Document title: DOE/Sandia Response to NMED's "Notice of Disapproval:
Mixed Waste Landfill Corrective Measures Implementation Work
Plan, November 2005" (Comment Set 2), January 2007

**DOE/Sandia Responses to NMED's
“Notice of Disapproval: Mixed Waste Landfill
Corrective Measures Implementation
Work Plan, November 2005”**

Comment Set 2

Part 2. Comments on the MWL Fate and Transport Model (Appendix E)

Figure 1. Trigger evaluation process for the Mixed Waste Landfill (revised)

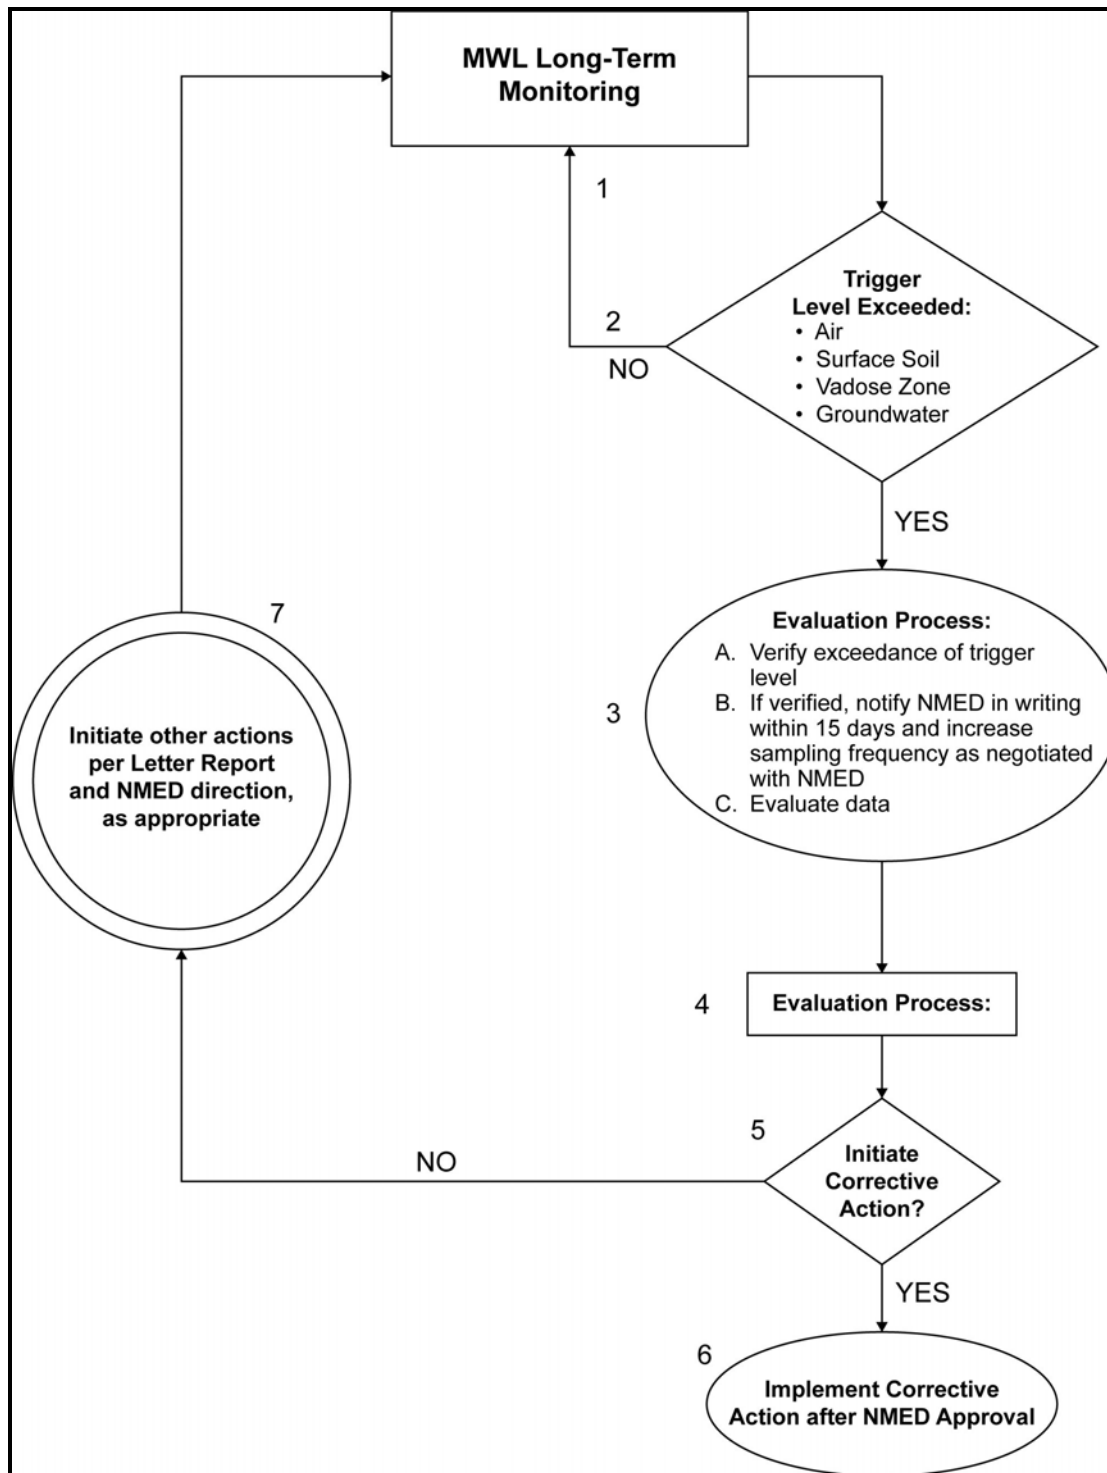
6. Section 4, Pages E-59 and E-59a -- Revise the trigger evaluation process to follow the corrective action process described in the Consent Order (April 29, 2004) if a trigger level is exceeded (step 3A), provided the Consent Order is still in force at the time the trigger level is exceeded. If the Consent Order has terminated, the trigger evaluation process

should follow the standard RCRA corrective action process.

Response: To be consistent with the Compliance Order on Consent (NMED April 2004) between the NMED, the DOE, and Sandia Corporation, hereinafter referred to as the Consent Order, several minor modifications were made to the trigger evaluation process figure on Pages E-59 and E-59a. The Consent Order requires notification of the NMED in writing within 15 days after the discovery of any previously unknown release of a Contaminant from a SWMU or Area of Concern. For consistency with the Consent Order, Step 3B on Figure E-25 has been revised to state, “If verified, notify NMED *in writing within 15 days* and increase sampling frequency as negotiated with NMED”.

In addition, the following line was added to Item 5 on Page E-59a, which explains the trigger evaluation process, “*If the NMED determines that further investigation of the trigger exceedance is needed, NMED may require corrective action based on a finding that releases of contaminants have occurred, are occurring, or are likely to occur.*”

The revised Trigger Evaluation Process is shown in Figure 1 below. All proposed monitoring triggers are considered preliminary at this point, and provide the basis for requirements to be established under the Long Term Monitoring and Maintenance Plan (LTMMP). Accordingly, this information is preliminary and will be finalized in the LTMMP which is required for submittal to NMED and subject to a public review and comment period.

Figure 2. (a) Conceptual model for infiltration model. (b) Nodal discretization in UNSAT-H.

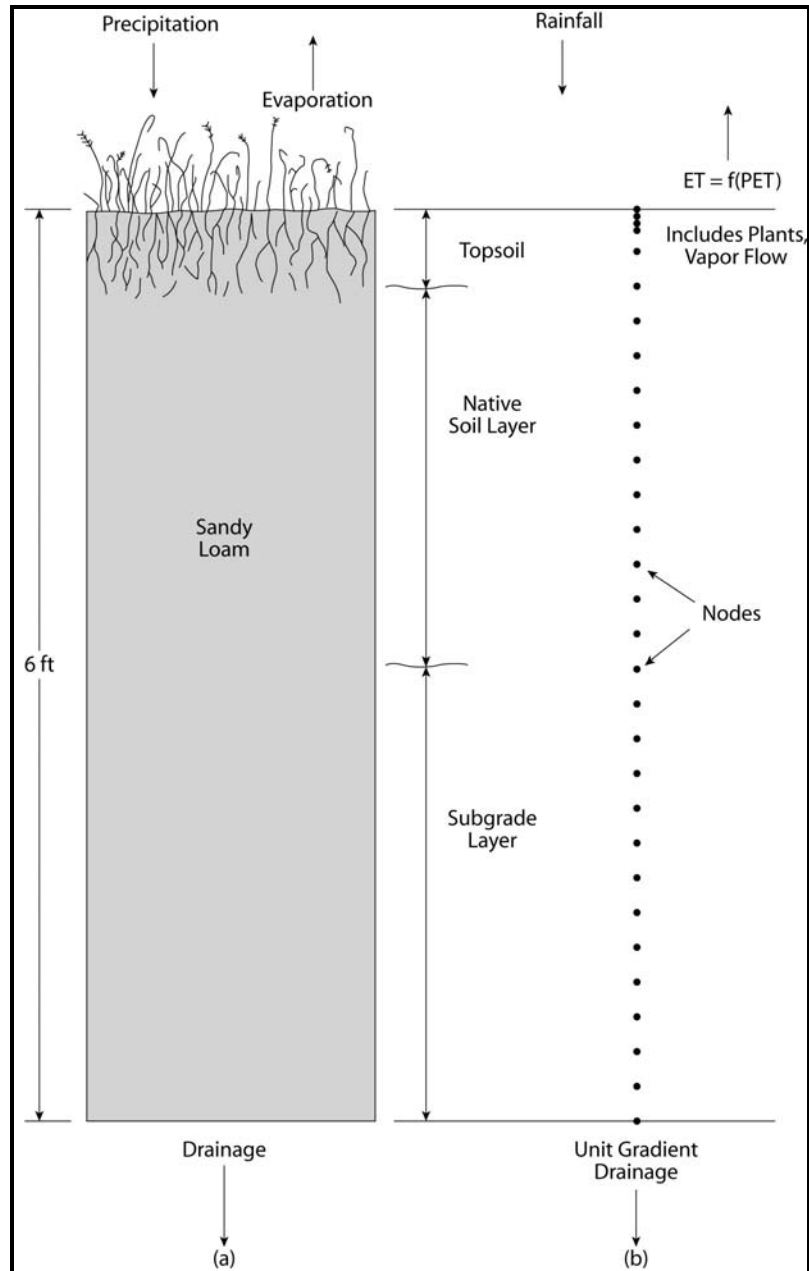
8. Section 3.4.1 --The first paragraph of Section 3.4.1 states the modeling study of water infiltration through the cover was "discretized by placing computational nodes at predetermined vertical spacing in a conceptual soil profile to evaluate the performance of a cover 3 ft in thickness." The model evaluated a soil profile that was actually 6 feet thick in order to avoid impacts due to boundary conditions, but these impacts and boundary conditions are not discussed. Thirty nodes were located within this 6-foot-thick soil profile. However, the discussion does not describe how or why the 30 node locations were predetermined within this soil profile. Explain the specific impacts caused by boundary conditions. Clarify how and why the computational node locations were predetermined.

The conceptual soil profile for the infiltration model, as discussed in Section 3.4.1, is presented side-by-side in Figure E-3 with nodal discretization used in the UNSAT-H model. As illustrated, the conceptual soil profile does not correspond to the components of the MWL soil cover cross-section. The soil profile illustration is dimensionless; i.e., it is not clear whether the soil profile is 6 feet thick. Also, only 23 of the 30 computational nodes within the cross-section are shown. In addition, the nodal depth locations cannot be determined from the illustration. Revise the Figure E-3 conceptual model to clearly indicate the components of the MWL soil cover (i.e., subgrade layer, biointrusion barrier, native soil layer, topsoil layer, and vegetation) and their location relative to the MWL waste zone. Revise Figure E-3 to include a vertical scale for depth (i.e., inches or feet below the cover surface) and the locations of all 30 computational nodes. Clarify the soil type specified for each component of the soil cover.

Response: Section 3.4.1 presents only a conceptualization of the model used to predict water percolation through the cover. A detailed description of the model and extensive discussion of the input parameters, boundary conditions, and results are discussed in the document, "Calculation Set for Design and Optimization of Vegetative Soil Covers, Sandia National Laboratories, Albuquerque, New Mexico" (Peace and Goering, 2005). Additional information from this report is included below.

Nodal Discretization versus Conceptual Soil Profile (Figure E-3):

The MWL cover was modeled as a lithologic monolayer to be conservative. A soil profile with uniform soil and hydrologic properties translates into a significant conservative estimate of liquid water flow, i.e. water flow is increased. If multiple layers are simulated, the water potential in the underlying layer must equal the water potential in the overlying layer before flow into the lower layer occurs. Multiple layering in performance modeling as well as multiple layers in nature attenuate the downward flow of liquid water (e.g., yielding multiple capillary barriers that slow water flow).

Figure E-3 does not show the actual components of the MWL soil cover (i.e., subgrade layer, biointrusion barrier, native soil layer, topsoil layer, and vegetation), because the model did not model each of these as individual components of the cover. Figure E-3 represents a conservative 3-ft thick, monolithic cover (i.e., the native soil layer, the topsoil layer, and the vegetation). The subgrade layer adds additional thickness to the lithologic monolayer represented by the modeled thicknesses of 4 and 5 ft. Although the biointrusion barrier was not modeled, its inclusion in the design does not adversely affect cover performance. In fact, the biointrusion barrier serves as a capillary break, further reducing the downward flow of water and adding additional conservatism to the estimate of net percolation by the model.

The figure has been revised to include a vertical scale for depth (i.e., feet below the cover surface) and the locations of all 30 computational nodes. However, to be true to the infiltration model, the biointrusion barrier, subgrade layer, and underlying wastes are not shown on the revised figure. The revised figure is shown below.

The soil type modeled for the cover is a sandy loam.
